## Product Update Notification

Product(s) affected:           MAC Panel part number **563700 Rev A**

New part number:                **563700 Rev B**

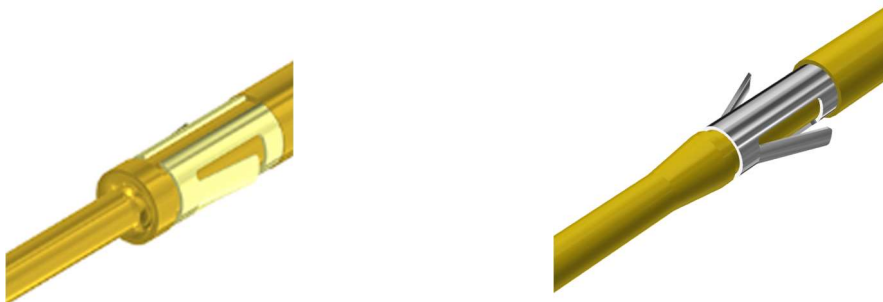
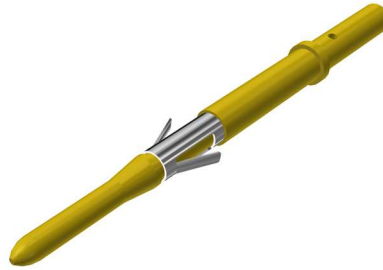
Reason:                            Product improvement for manufacturability, automated clipping

- Yes, the appearance of contact is different. Contact has a tapered nose versus a sharp shoulder.
